**LIST OF FIELD MODIFICATIONS
ENGINE DRIVEN D-C GENERATOR
TYPES 30E16-1-A, 30E16-1-C AND 30E16-11-C
ECLIPSE PIONEER**

MODIFICATION INSTALLATION OF SHAFT ASSEMBLY RCAF DRAWING 35416-1

(This EO replaces EO 40-10BL-6A/1 dated 16 Mar 60)

Figure 1 (Issue 1)

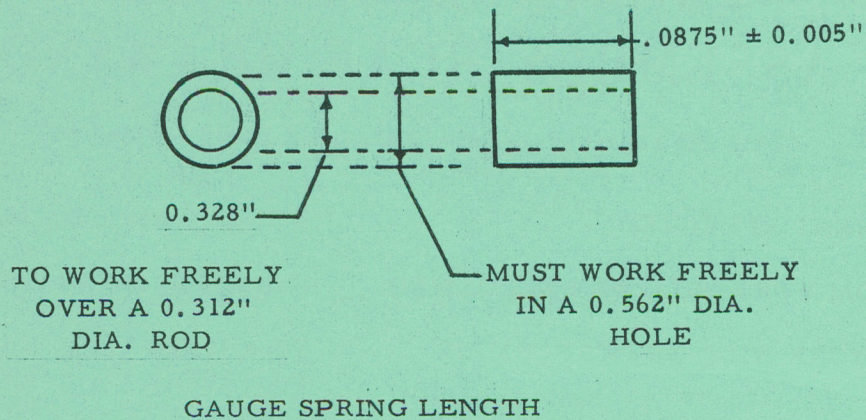
2 Manufacture locally from available materials the spring length gauge as detailed in Figure 1 and retain for further installations. Refer to EO 40-10BL-4 Parts List for parts identification. The following is the sequence of operations:-

- (g) Install shaft 35416-1, lining 1107478 and plate 862179 in armature assembly.
- (h) Temporarily fit gauge (manufactured as detailed in Figure 1) in armature cavity and install washer AN960-416 and nut AN364-428C (removed in para. 2(c)).
